**SHEARON HARRIS NUCLEAR POWER PLANT, UNIT NO. 1
DOCKET NO. 50-400/LICENSE NO. NPF-63
FREQUENTLY ASKED QUESTIONS (FAQS), REQUESTING ADDITIONAL
GUIDANCE OR CLARIFICATION REGARDING TRANSITION TO NFPA-805
"PERFORMANCE BASED STANDARD FOR FIRE PROTECTION FOR LIGHT
WATER REACTOR ELECTRIC GENERATING PLANTS"**

FAQ 06-0001

Plant:	<u>Harris Nuclear Plant (HNP)</u>	FAQ # <u>06-0001</u>
Submittal Date:	<u>04-25-06</u>	
Licensee Contact:	<u>Jeff Ertman</u>	Tele/email <u>919-546-3681</u>
NRC Contact:	<u></u>	Tele/email <u></u>

Figure B-5 Acceptable Manual Action in Fire Area Meeting 10 CFR 50, Appendix R, Section III.G.2 Compliant – Manual Action for Fire Affected Train

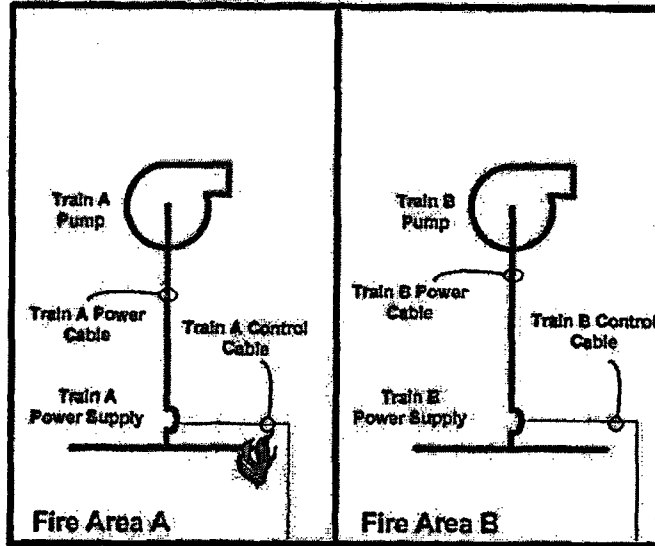
- Operation of fire affected equipment in fire areas that meet the separation requirements of Section III.G.2 of 10 CFR 50, Appendix R (or applicable sections of NUREG-0800) for redundant trains. See Figure B-5.

Fire Area B meets the separation criteria of 10 CFR 50 Appendix R, Section III.G.2.a. A postulated fire in Fire Area A could result in the spurious starting of the non-credited Train A pump, which can be mitigated by a manual operator action to de-energize the Train A Power Supply to stop Pump A. This is functionally equivalent to Case in Figure B-4.

Add new figures (B-4 & B-5) to NEI 04-02 to illustrate fire affected train operator manual actions (where credited train is protected in a fire area, e.g., 3-hour wrap, that includes the fire affected train operator manual action). Configurations shown are functionally equal for the fire affected train of equipment and as such would not require prior regulatory approval for change.

Figure B-4 Acceptable Manual Action in Fire Area Meeting 10 CFR 50, Appendix R, Section III.G.1 Separation Criteria

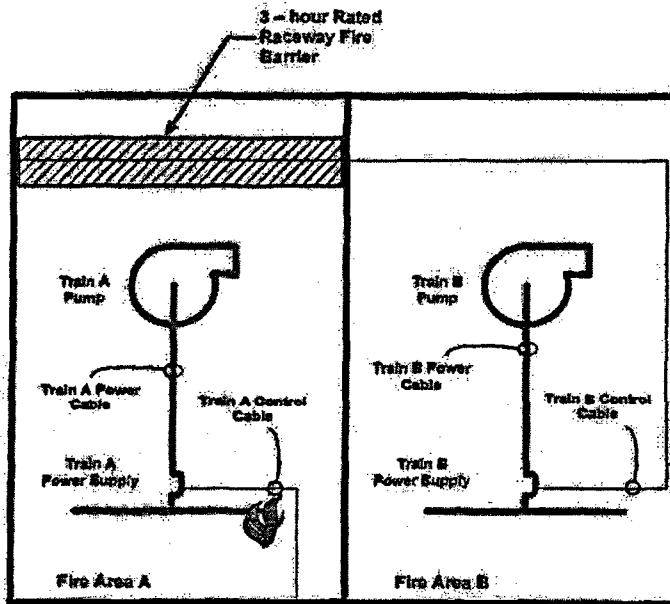
- Operation of equipment for which cables and equipment for the redundant safe shutdown train are located in separate fire areas thus meeting Section III.G.1 of 10 CFR 50, Appendix R (or applicable sections of NUREG-0800). See Figure B-4.

Fire Area A and B meet the separation criteria of 10 CFR 50 Appendix R, Section III.G.1. A postulated fire in Fire Area A could result in the spurious starting of the Train A pump, which can be mitigated by a manual operator action to de-energize the Train A Power Supply to stop Pump A.
